Tennessee Valley Authority, 1101 Market Street, Chattanooga, Tennessee 37402-2801

SEQUOYAH NUCLEAR PLANT (SQN) UNITS 1 AND 2 - PREEMPTIVE WELD OVERLAYS (PWOL) ON ALLOY 600 PRESSURIZER NOZZLE-TO- PIPE WELDS AND ASSOCIATED ALTERNATIVE REPAIR TECHNIQUES - GENERIC REQUEST FOR RELIEF G-RR-1 - SUPPLEMENTAL INFORMATION (TAC NOS. MD2381 & MD2382)

Sketches 1 and 2

ILLUSTRATION SKETCH NO.1 (R2)

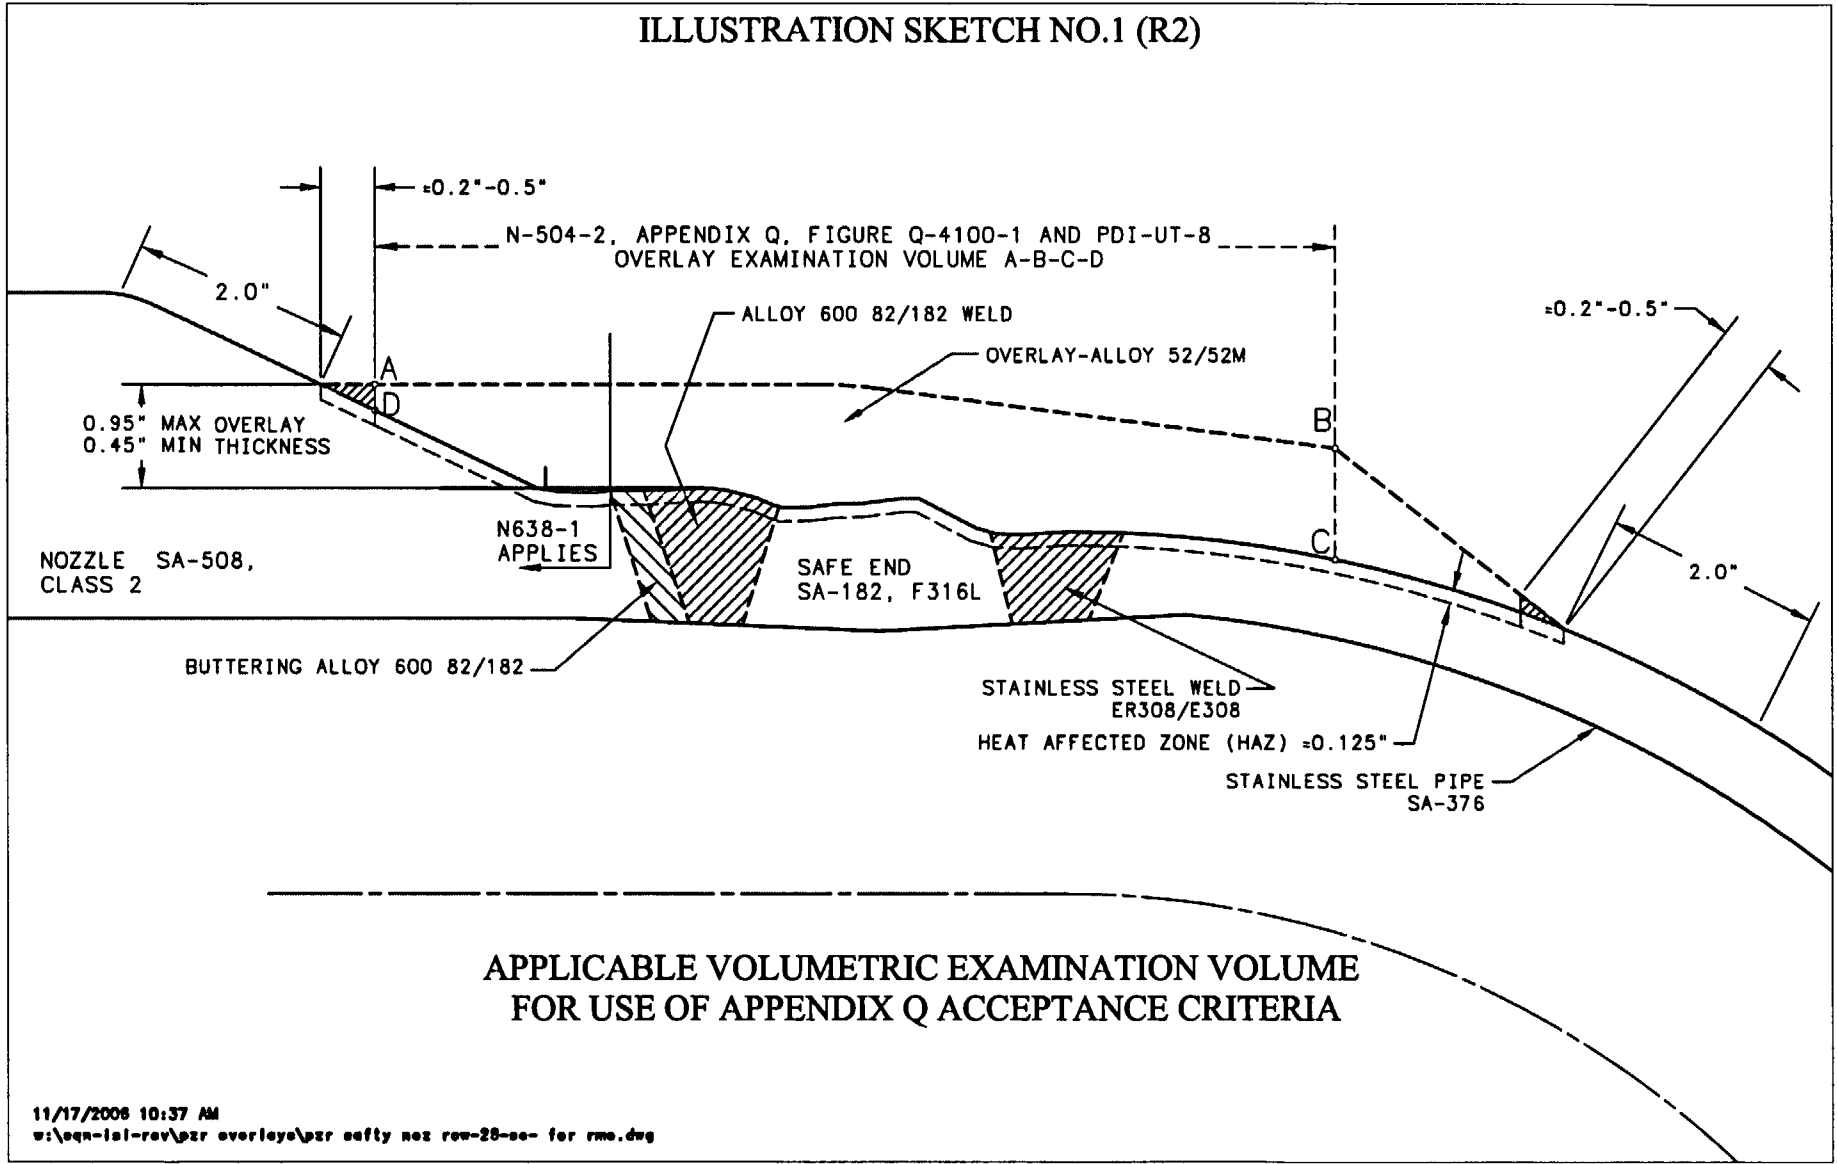
During the telephone call, NRC provided verbal approval for TVA's Generic Relief Request No. G-RR-1 for SQN Unit 2 in accordance with NRC Office Instruction LIC-102, Revision 1, "Relief Request Reviews." For additional clarification, NRC requested that TVA revise and resubmit the sketches previously provided in TVA's supplemental letter to NRC dated October 20, 2006. Specifically, NRC requested that point A and D on the sketches be relocated to show polished areas of the welds. Accordingly, the revised sketches are enclosed.

Also, in the follow-up telephone conversation, NRC clarified that commitment note No. 3 found in Enclosure 2, "List of Commitments," of TVA's letter dated October 20, 2006, is superseded by the sketches enclosed herewith. Thus, TVA withdraws note No. 3 applicability from the "List of Commitments."
